# ADDENDUM 1

**Project:** HARRISON PARK ACADEMY – NEW HEALTH CLINIC

**Date:** October 7, 2024

**Project No.:** 1322

**FIRST FLOOR PLAN AND DEMOLITION PLAN**

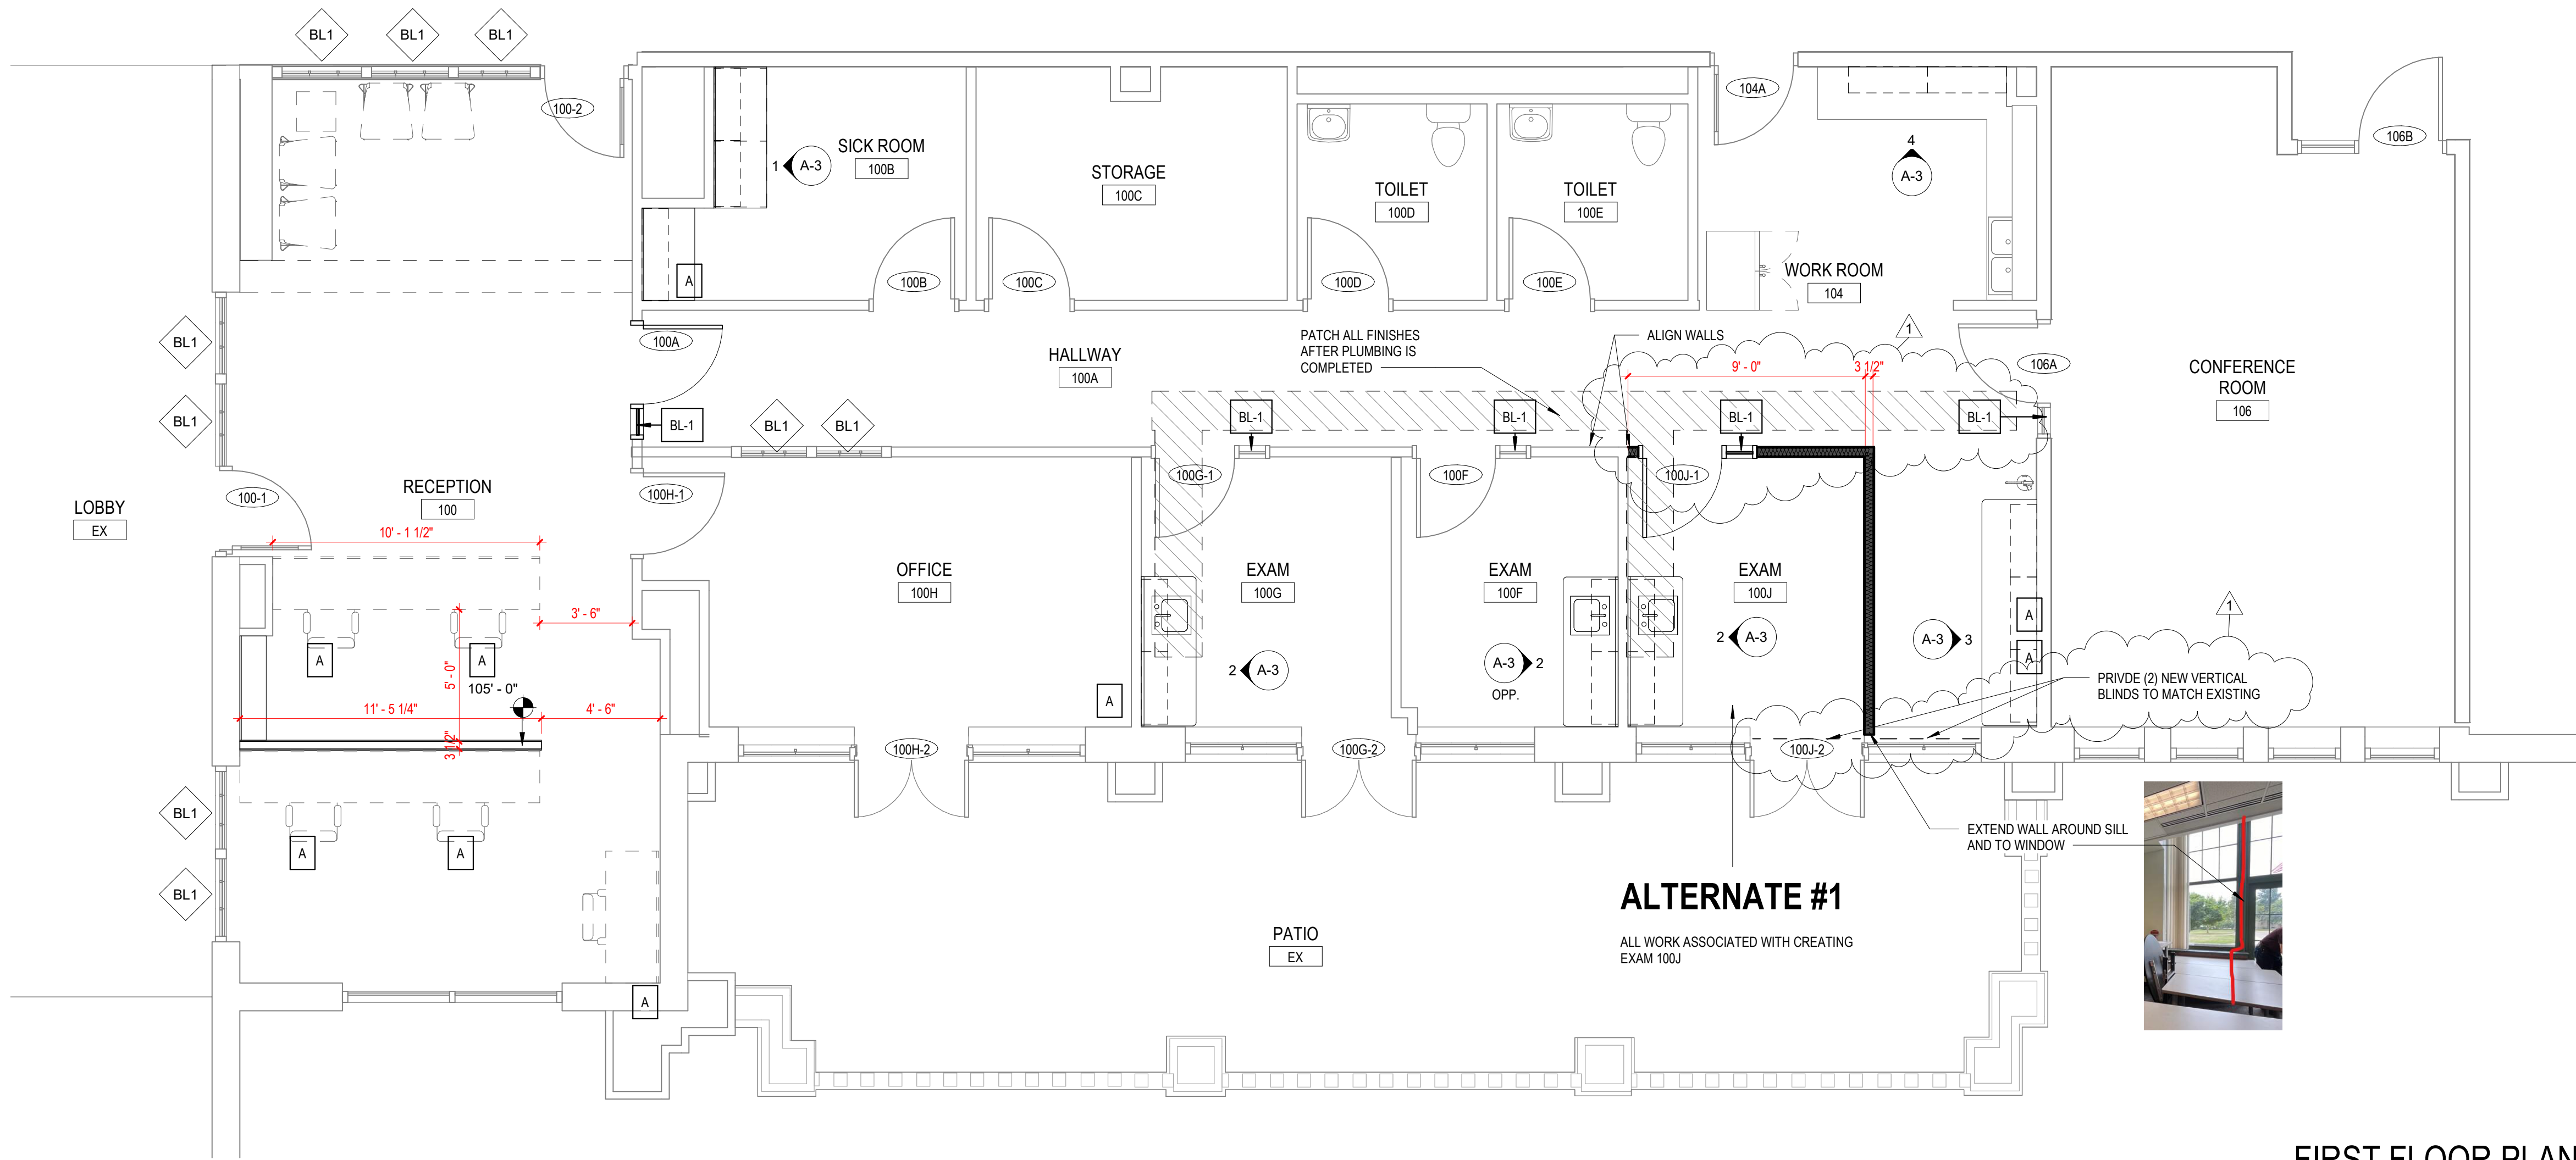
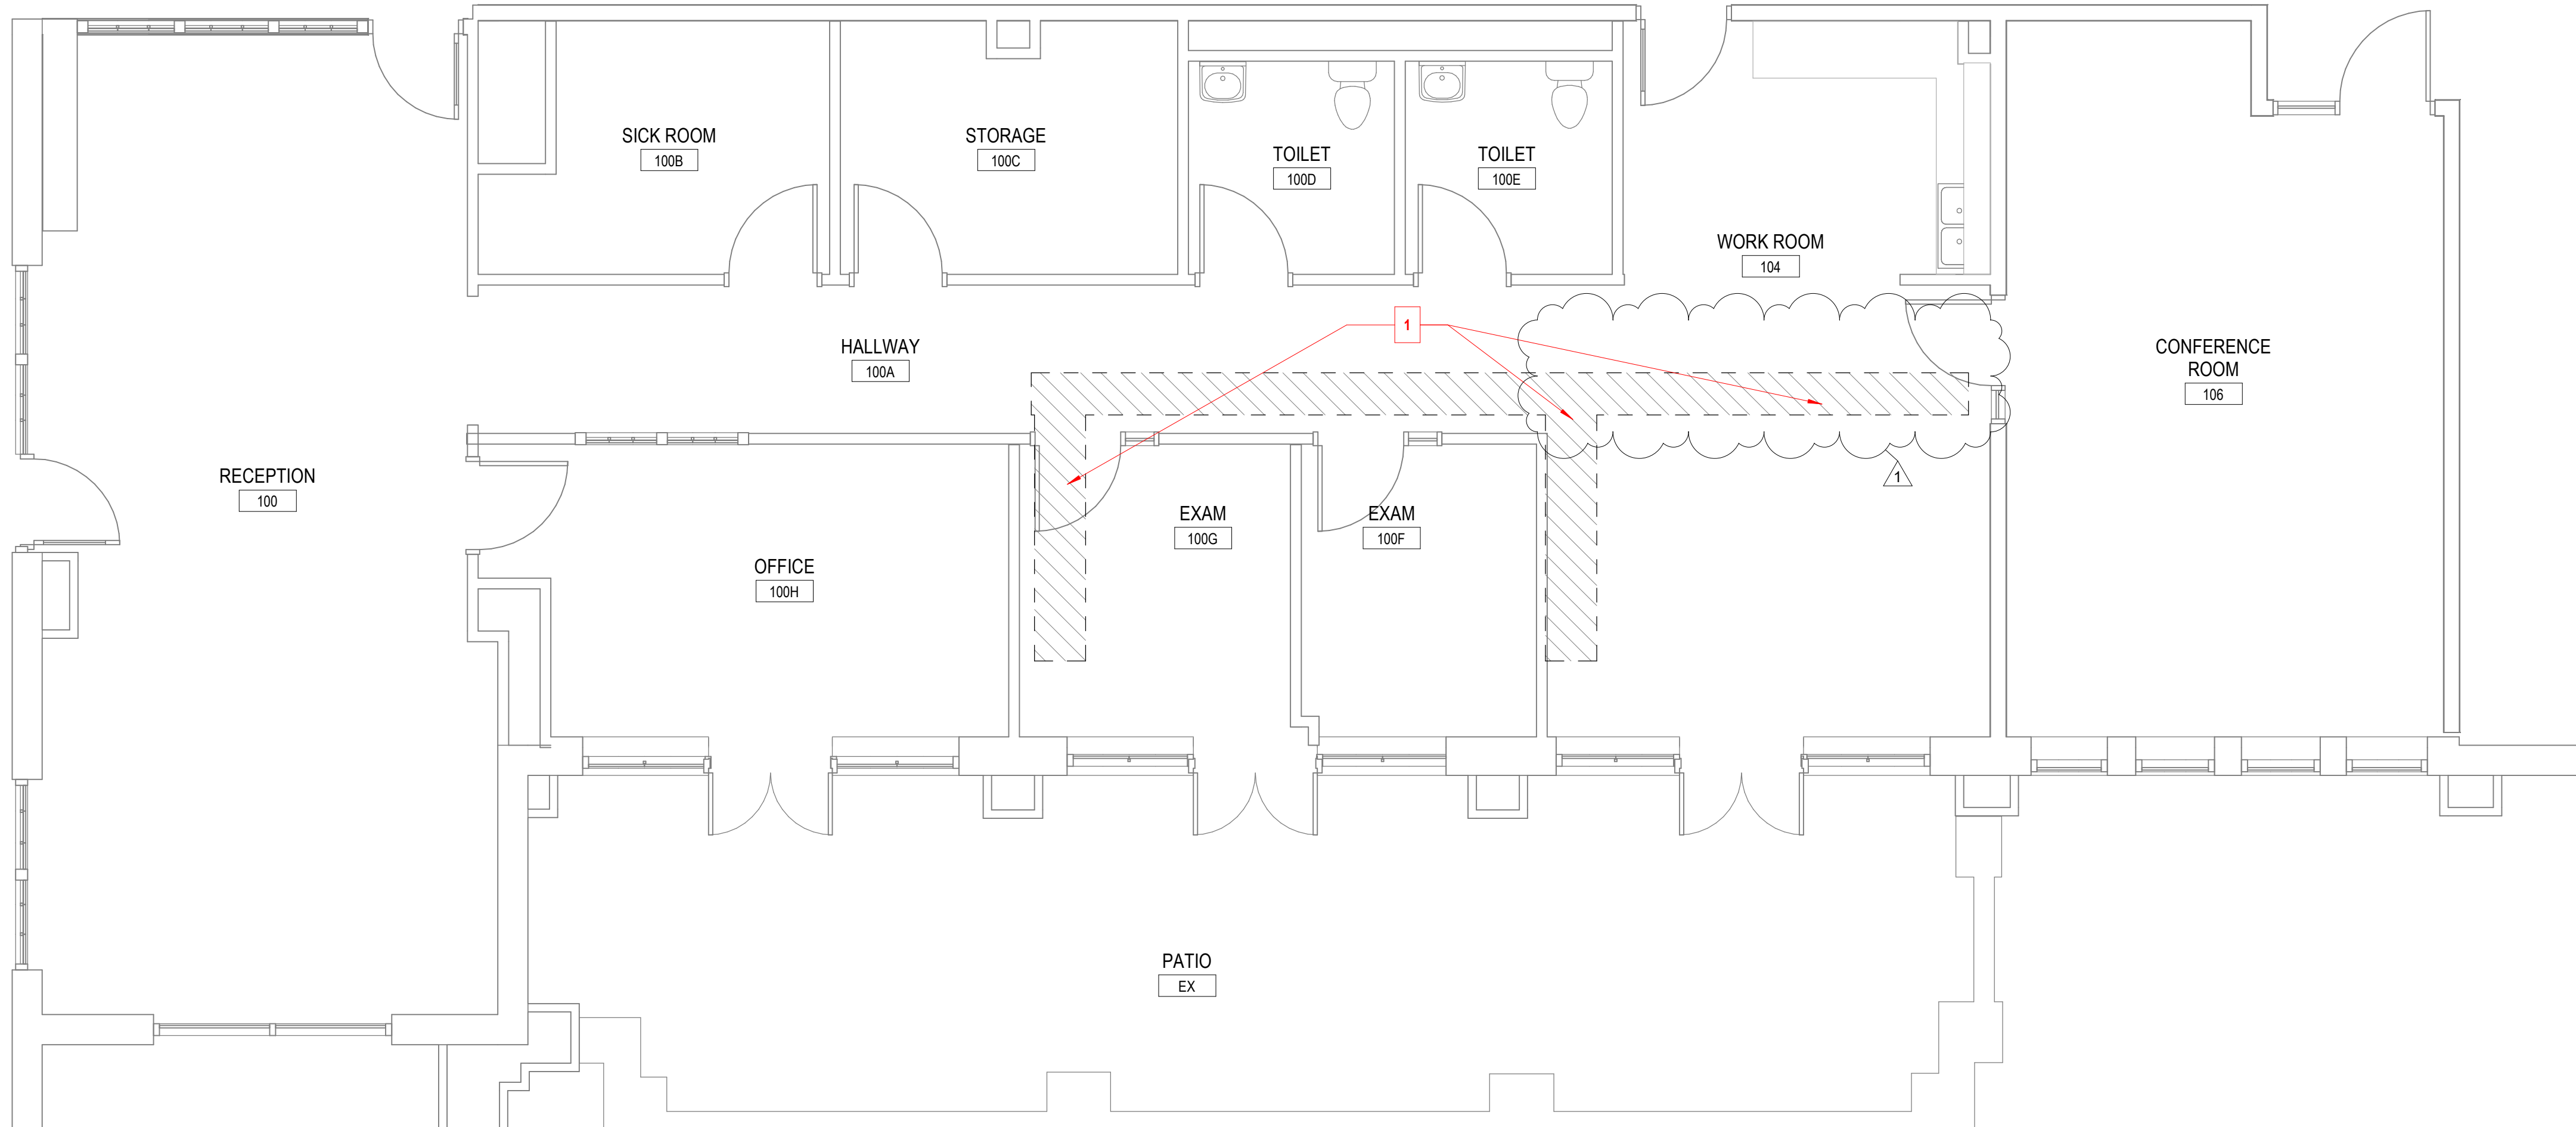
9. See A-1 for sawcut adjustment.
10. Existing breaker panel is located directly across the Corridor of Room 100.
